Garrison Farmhouse

Add/Reno - Hodgdon Residence

HODGDON COMMENTS -RED INK 9/27/2021

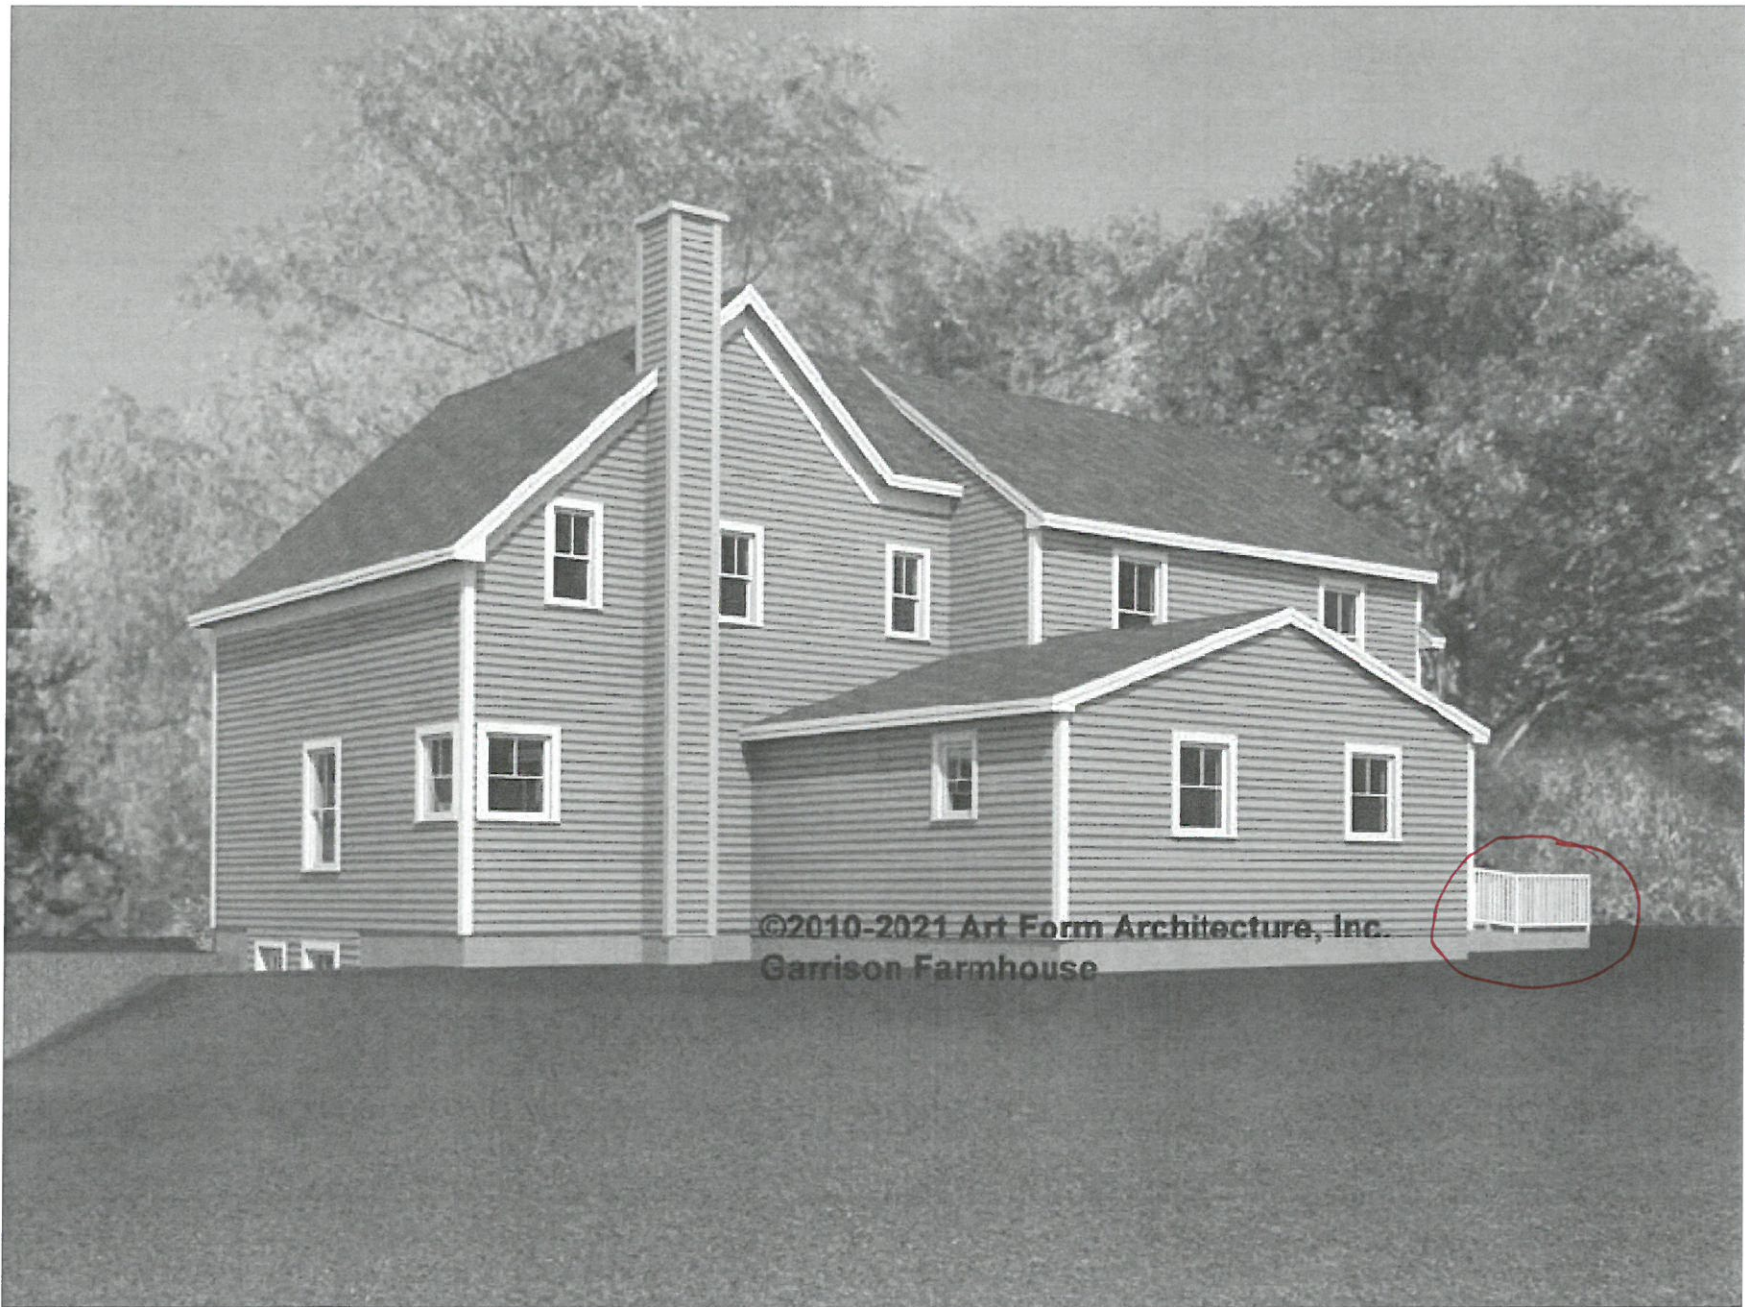
ELIMINATE
RAMP (TYP.)

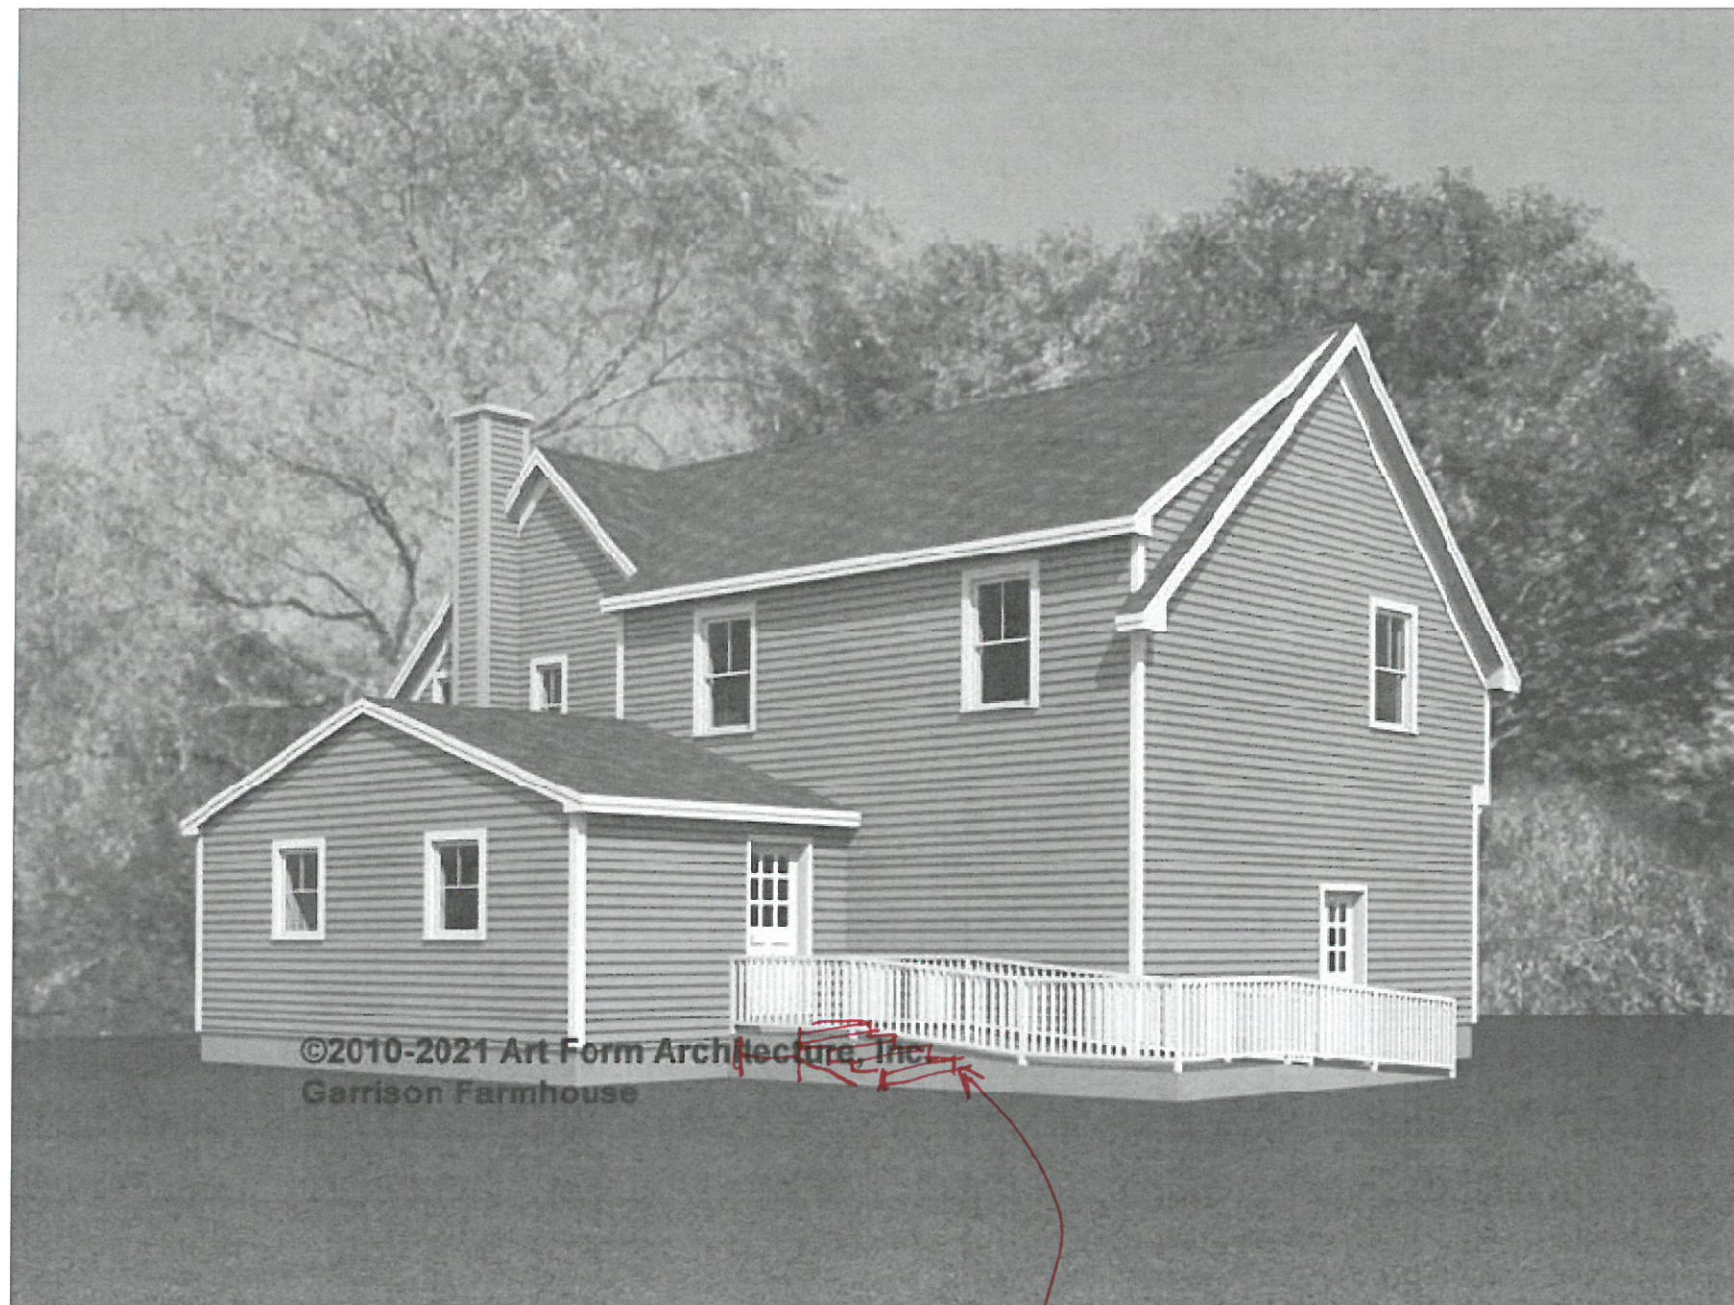
BUILDER: WOULD LIKE TO ALLOW FOR POTENTIAL FUTURE DECK ALONG BACK SIDE OF ADDITION THAT WRAPS AROUND TO HOUSE. CONSIDER THIS IN FRAMING /SILL

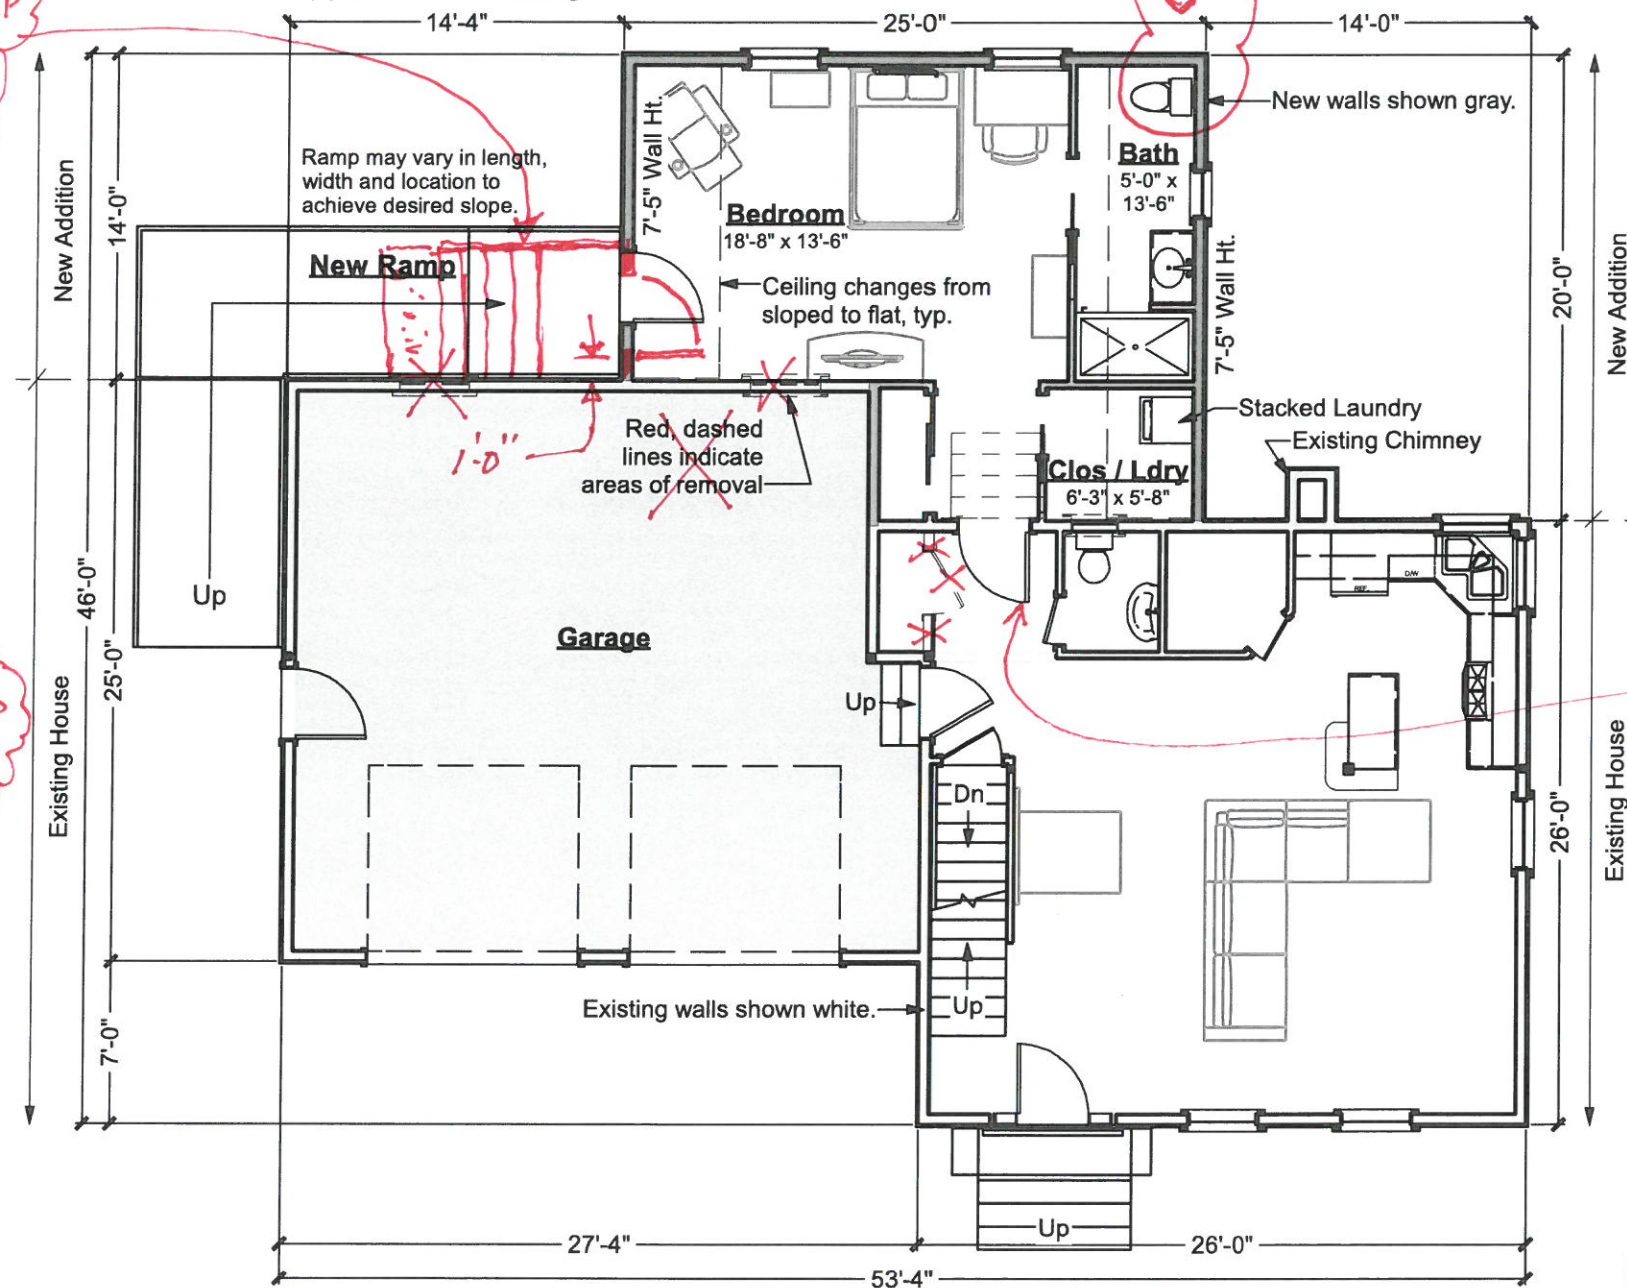
REPLACE WRAP AROUND RAMP w/ STEPS 3'x5' TOP LANDING ±

Interior Views Existing House - 2nd Floor Bedrooms

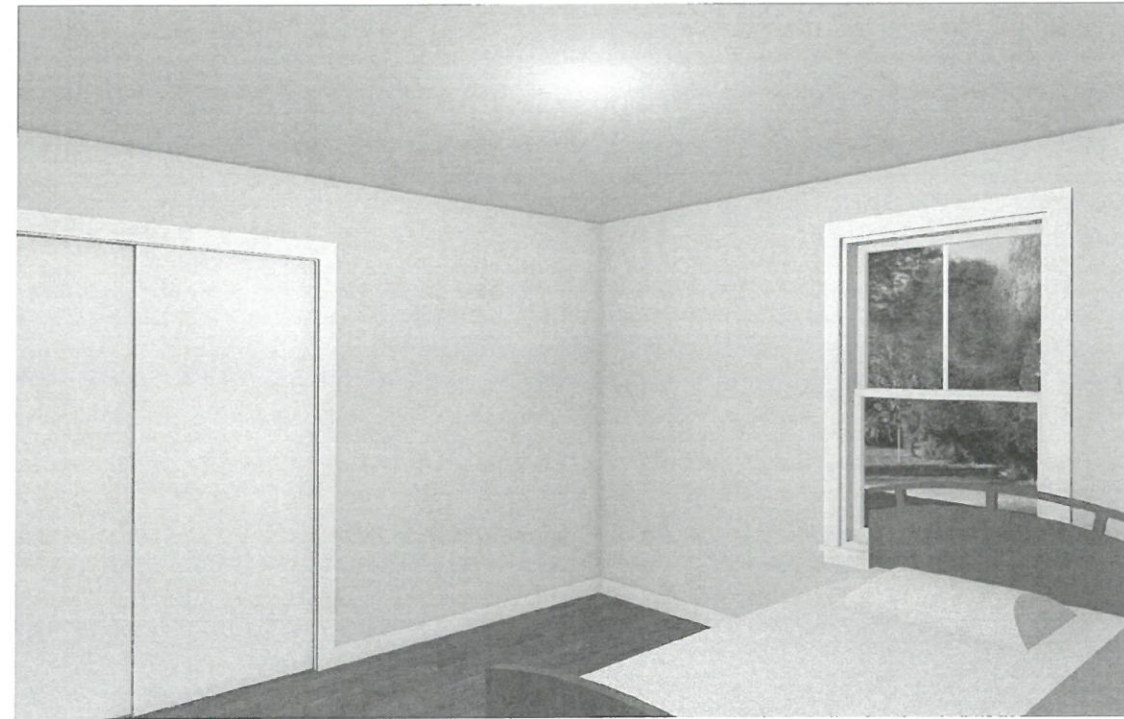
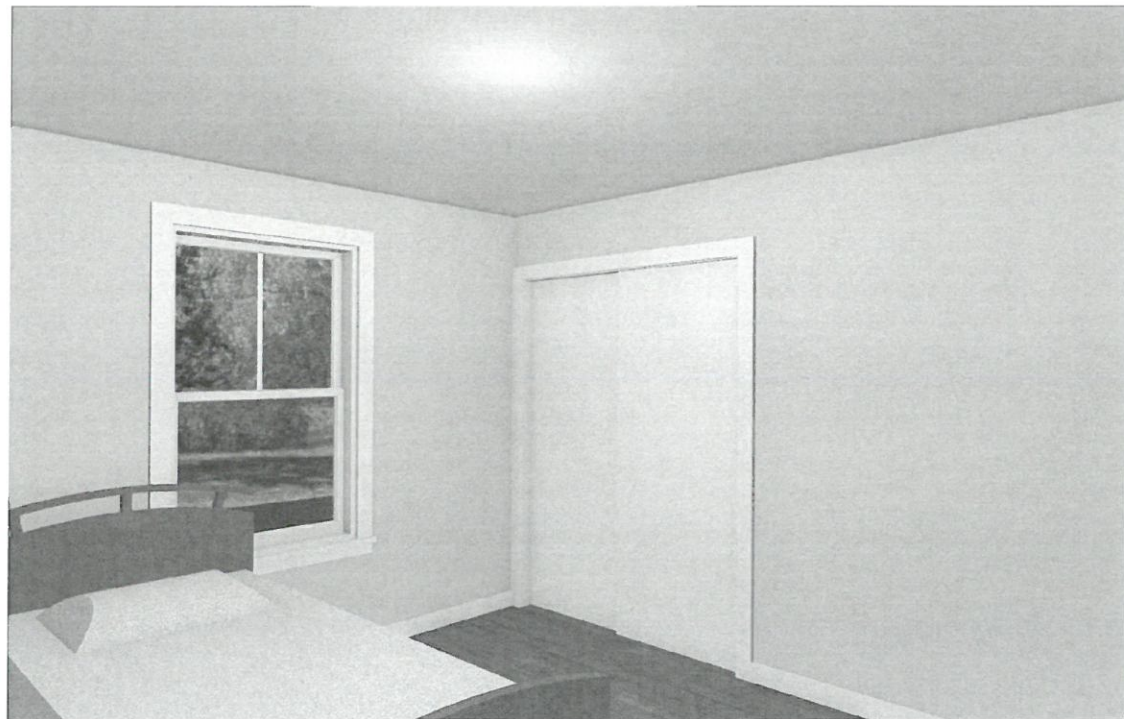
REMOVE THESE RENDERINGS FROM
PROJECT AND CONST. DWGS.
